**ASSESSMENT OF
ENVIRONMENTAL ISSUES
FOR THE PROPOSED
KYOTO ENERGY PARK –
AVIATION**

Client	Pamada Pty Ltd
Contact	Mark Dixon
Document No	2621/PR/004
Issue No	C
Status	Final
Classification	Client's Discretion
Date	28 August 2008

Response to Aviation Issues
from the Department of Defence
(12 March 2008)

PROPOSED KYOTO ENERGY PARK - SCONE NSW

Figure 11 Circling protection surface overlaid with terrain surface + 150m (revised 42 turbine layout)

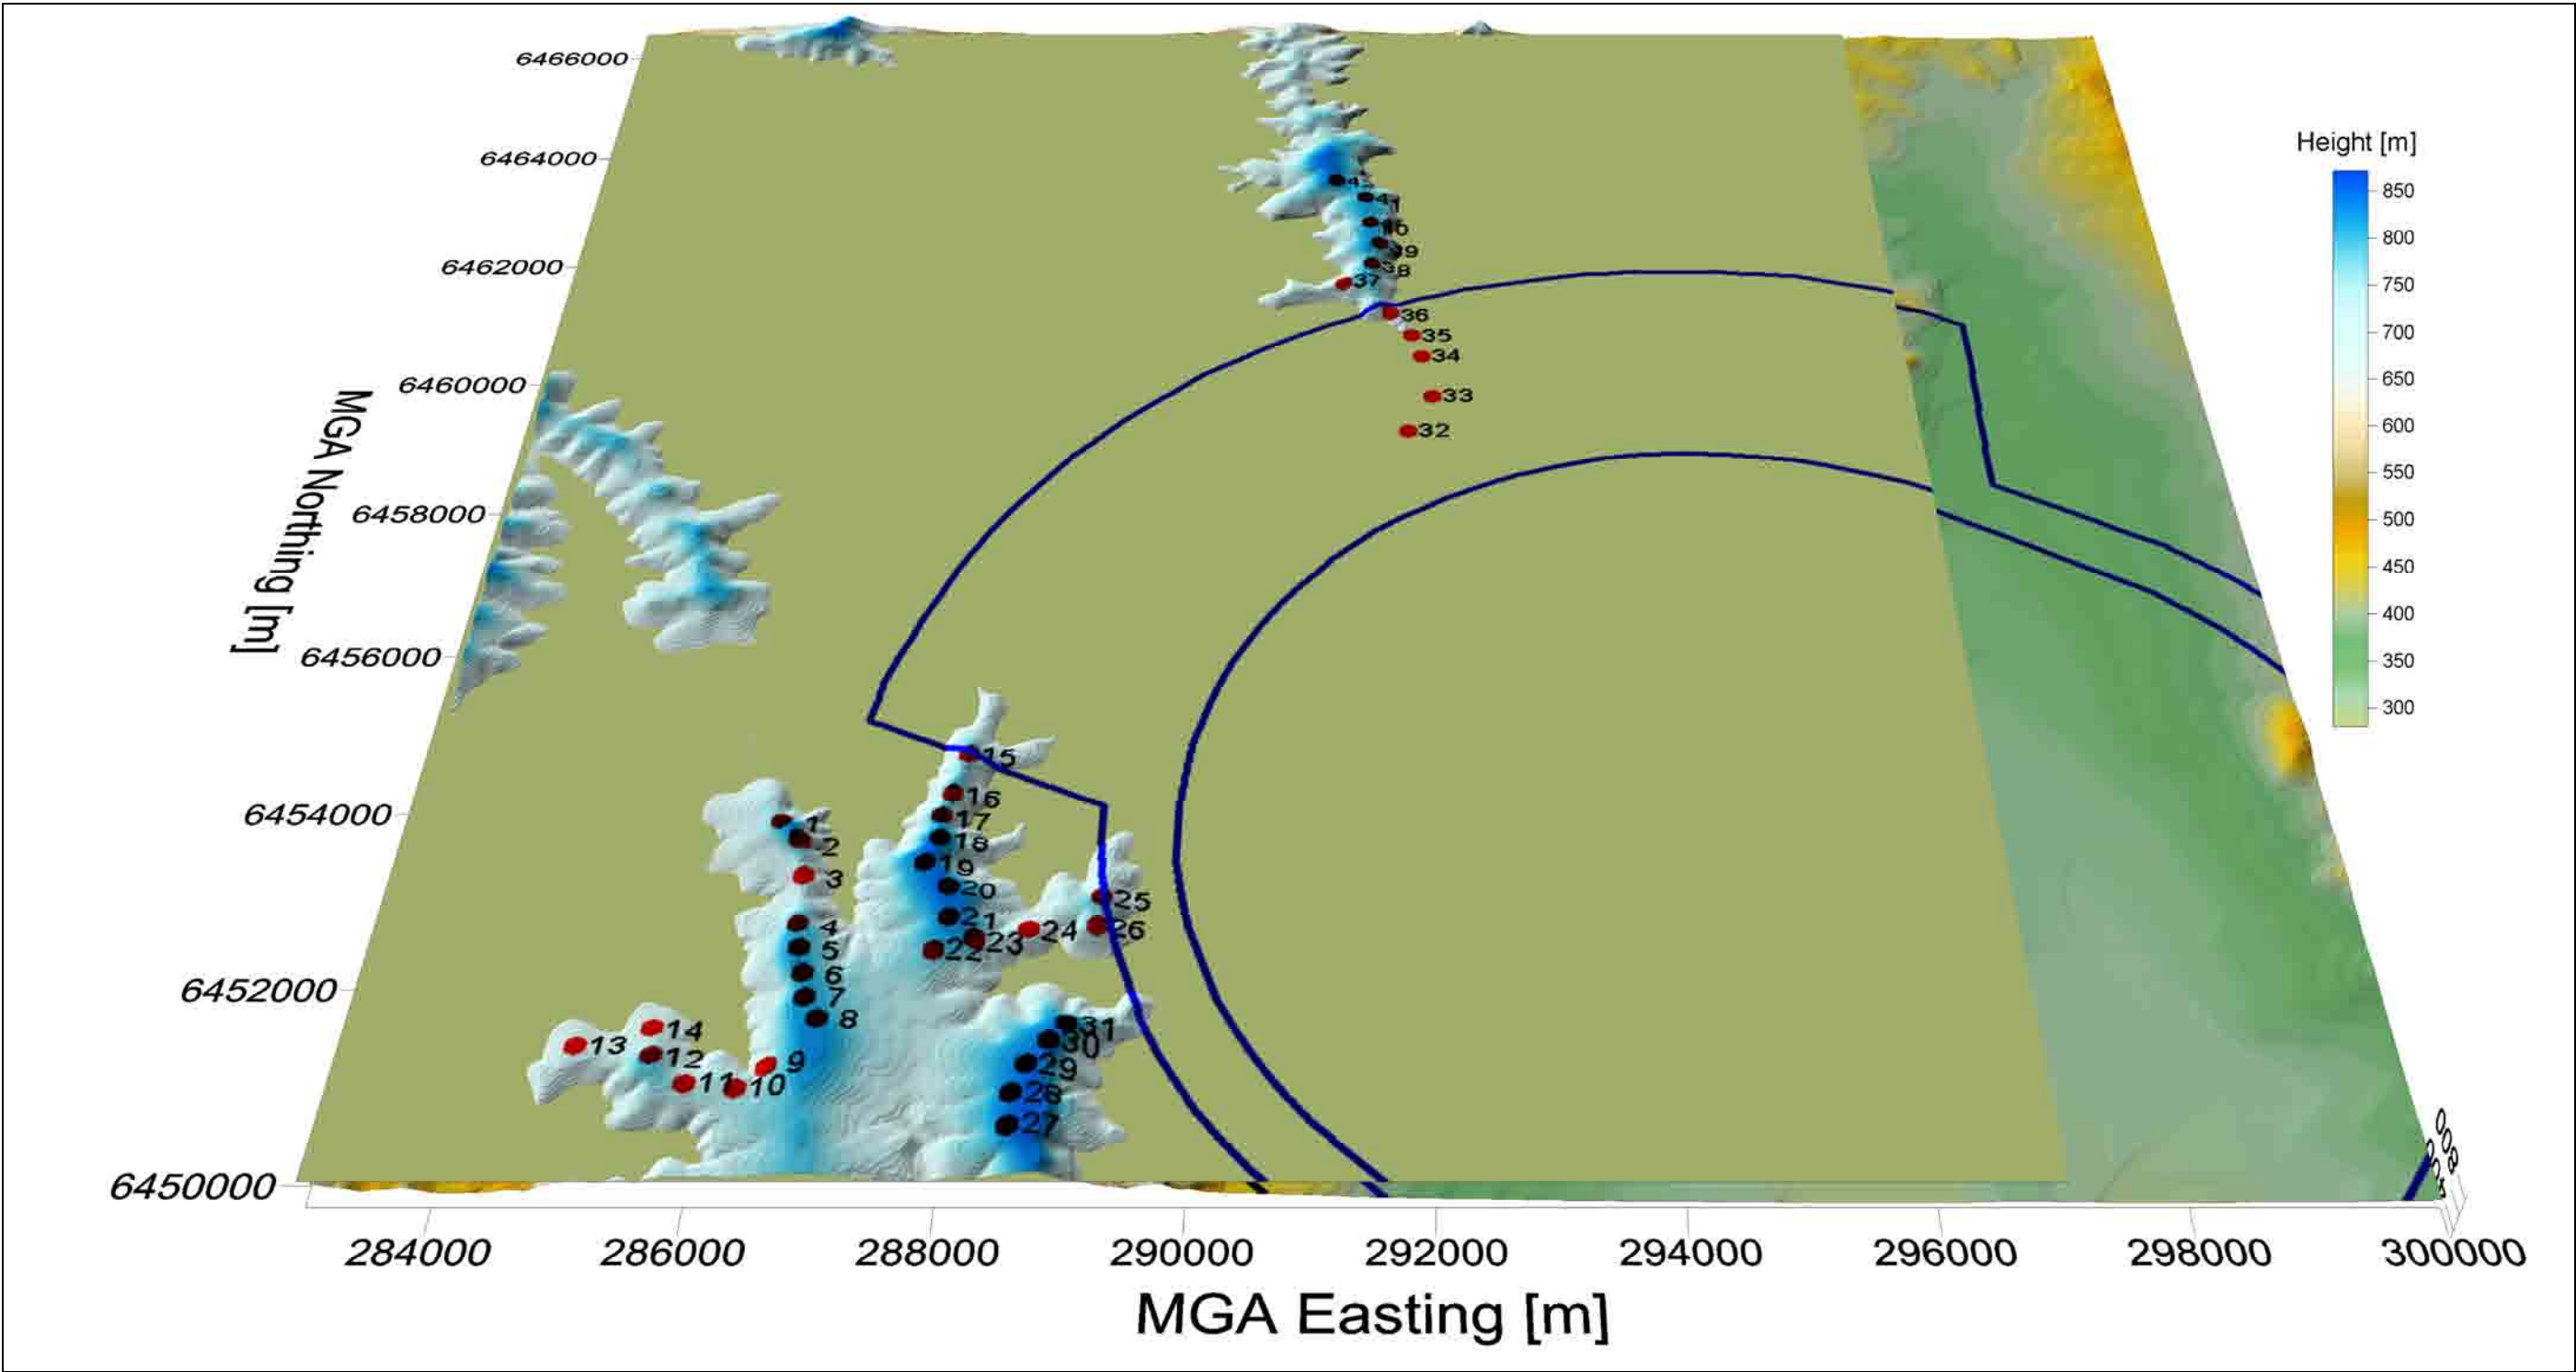
Airservices Australia indicated that turbines 15 and 39 from the original 47 turbine layout infringed the CAT C Circling procedure [7]. GH concurred with this finding.

As discussed in Section 3.2.1 turbine 15 was relocated 80m to the south and now avoids infringing the CAT C Circling procedure.

Turbine 36 from the revised 42 turbine layout still infringes the CAT C Circling procedure, however this finding is superseded by the fact that turbine 36 already infringed the 29RNAV procedure as detailed above.
